CHANGE LIST

Model CT3/5 MB BOARD

CT3/5 MB
31CT3MB0015
31CT3MB0031

2A

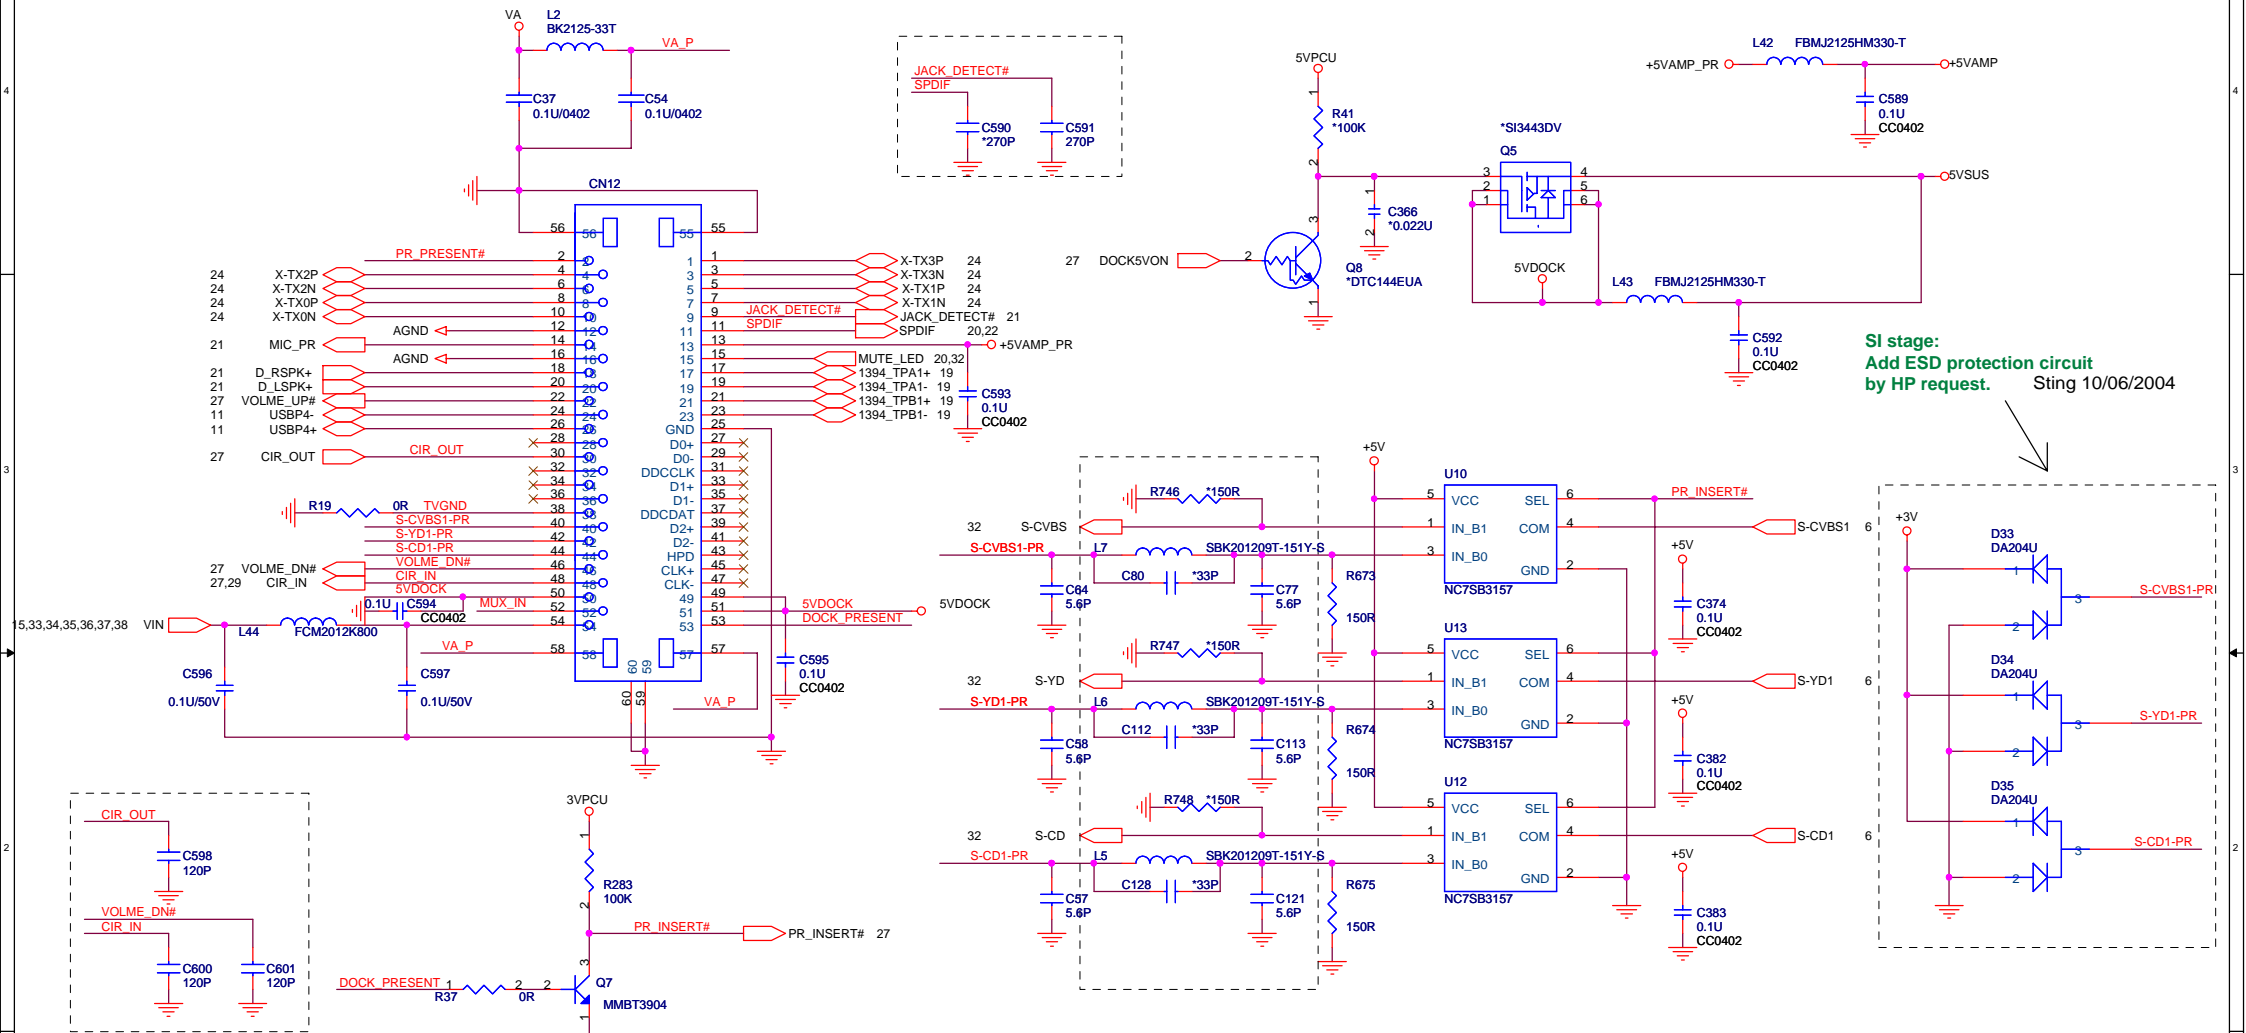
SI stage:
Add ESD protection circuit
by HP request. Sting 10/06/2004

PV stage:
1. Change L5,L6,L7,C57,C58,C64,C77,C113,C121 value to improve S-video quality.
2. Reserve S-video impedance match circuit.

SI stage:
Add R713 to enable the mux in the Tampa-2 cable.
(connects the component TV output to the composite/Svideo output lines).

CPU VCC_CORE (MAX1907)

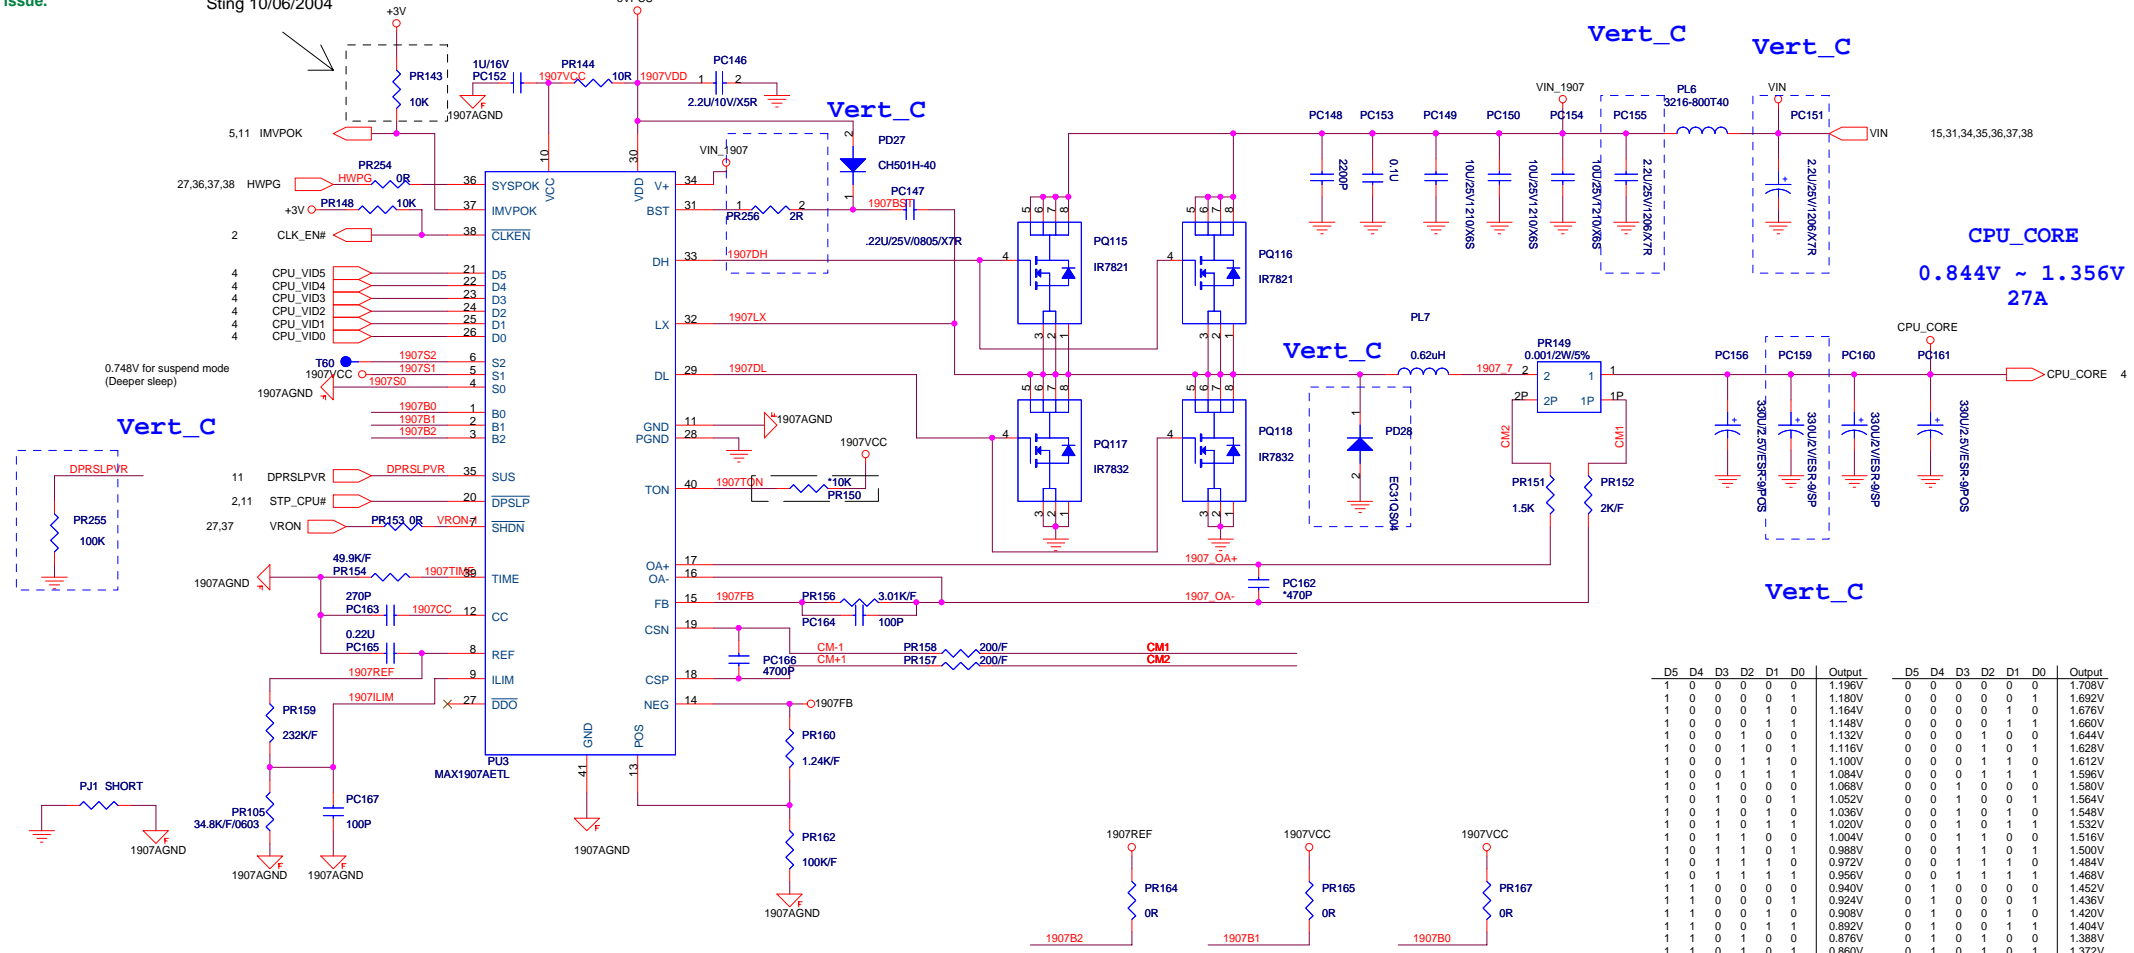
SI stage:
Change PR143 value from 100K ohms to
10K ohm to solve panel display abnormal
issue.

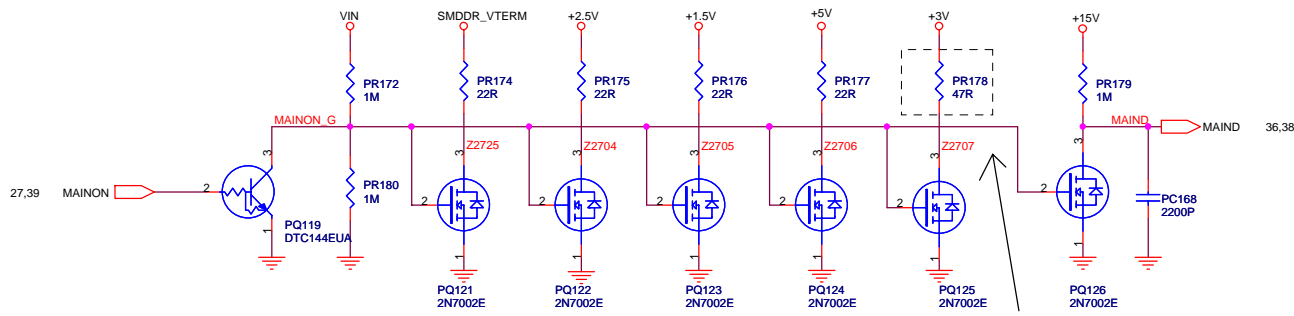
SI stage:
Change PR178 value from 22 ohm to 47 ohm, Intel has required the timing sequence of +1.5V and +3V in the system, we'd like to increase the value to make +3V discharge slowly to meet the specification of falling time.
